Report to the Future Melbourne Committee

Planning Permit Application: TP-2021-318 299 Bourke Street and 278-286 Little Collins Street, Melbourne

9 November 2021

Figure 24: Subject site (Bourke Street) demonstrating concealed additions

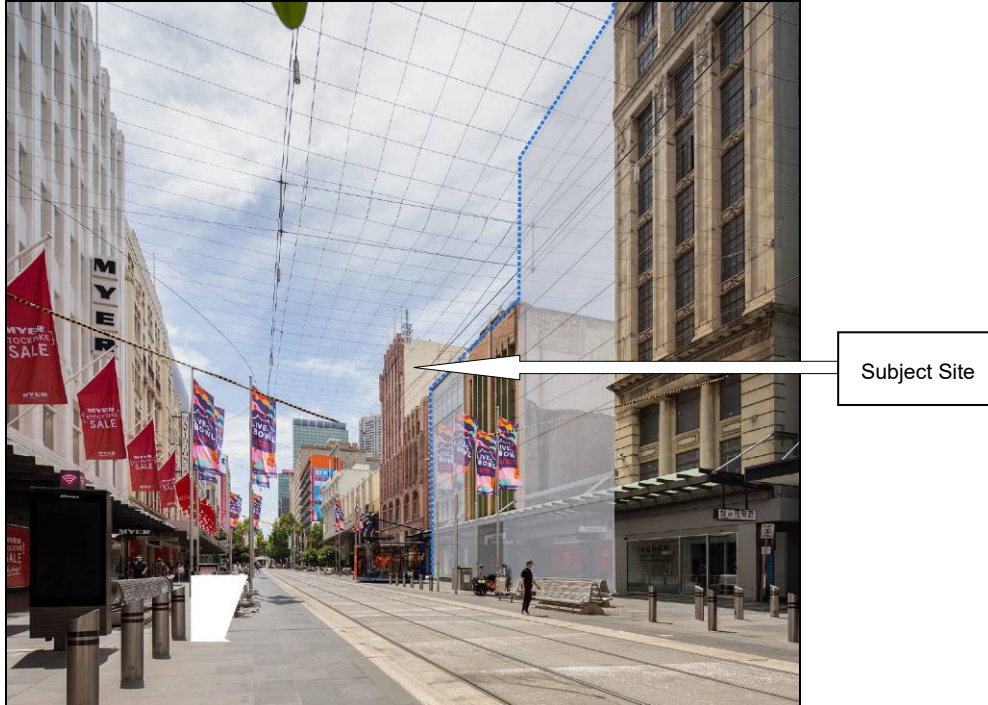
The submitted massing studies demonstrate a concealed upper form when viewed from key vantage points within Bourke Street Mall. While the study demonstrates a portion of the upper addition being perceptible upon approach from the east within Little Collins Street, this element is considered to be recessive and complementary to the retained heritage form. From an urban design perspective, the massing response is appropriate and respectful within this sensitive context.
